Access Compliance Report

Public Rights-of-Way

(Curb Ramps)

Intersection ID: 15287	Main Street: ALBEMARLE_RD	Cross Street: N_SHARON_AMITY_RD	Location: NE
ADA ID: D1265FC8816B	Ramp Type: Perp	Initial Pass/Fail: Fail	Overall Compliance: No
Codes/Mitigation Info/Possible Solution		Field Measurements/Component Compliance	
Severity Score: 33.75

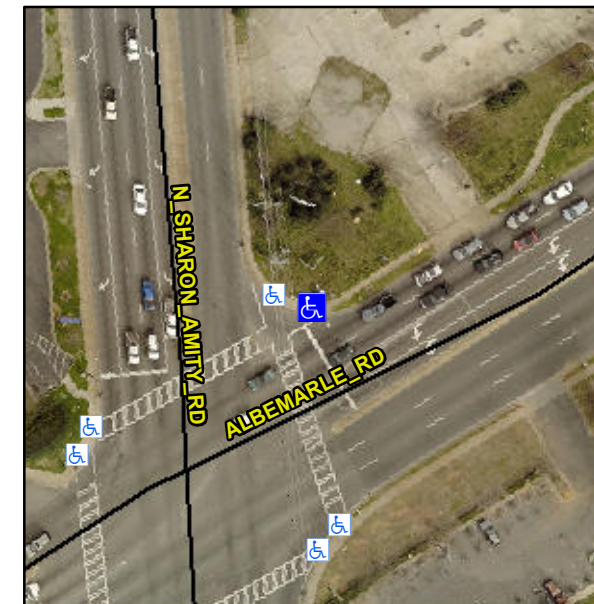
**Not Found, R304.5.1, R304.2.2,
R304.5.3**

Compliance	Description	Data	Compliance	Description	Data
N/A	Ramp Length (in)	58.0	No	Ramp Slope (%)	9.1
No	Ramp Width (in)	46.0	No	Ramp XSlope (%)	5.7
N/A	Flare Type LT	N/A	N/A	Flare Type RT	N/A
N/A	Flare Slope LT (%)	N/A	N/A	Flare Slope RT (%)	N/A
N/A	Flare Traversable LT?	N/A	N/A	Flare Traversable RT?	N/A
N/A	Landing Length (in)	N/A	N/A	DWS Provided?	N/A
N/A	Landing Width (in)	N/A	N/A	DWS Contrast?	N/A
N/A	Landing Slope (%)	N/A	N/A	DWS Length (in)	N/A
N/A	Landing X Slope (%)	N/A	N/A	DWS Full Width?	N/A
N/A	Landing Curb? (Y/N)	N/A	N/A	DWS Offset (in)	N/A
N/A	Shared Landing?	N/A			
N/A	Gutter Ponding?	N/A	N/A	Gutter Slope (%)	N/A
N/A	Gutter Lip Ht (in)	N/A	N/A	Gutter X Slope (%)	N/A
N/A	Painted X Walk1?	Yes	N/A	Painted X Walk2?	N/A
	X Walk 1 Direction	To S		X Walk 2 Direction	N/A
N/A	X Walk 1 Width (in)	110.0	N/A	X Walk 2 Width (in)	N/A
	X Walk 1 Slope (%)	3.0		X Walk 2 Slope (%)	N/A
	X Walk 1 X Slope (%)	3.1		X Walk 2 X Slope (%)	N/A

N/A	Ramp inside XWalk1?	No	N/A	Ramp inside XWalk2?	N/A
	Road Slope (%)	N/A	N/A	Clear Space?	N/A
	Road X Slope (%)	N/A	N/A	Clear Space to XWalk (in)	N/A
N/A	Any Obstructions?	N/A	N/A	Storm Grate/Utility Hazard?	N/A
	Obstruction Type			Storm Grate/Utility Type	
		N/A			N/A
			Yes	Surface Condition? (G/P)	Good

**Remove & Replace Entire Ramp.
Restripe Crosswalk.**
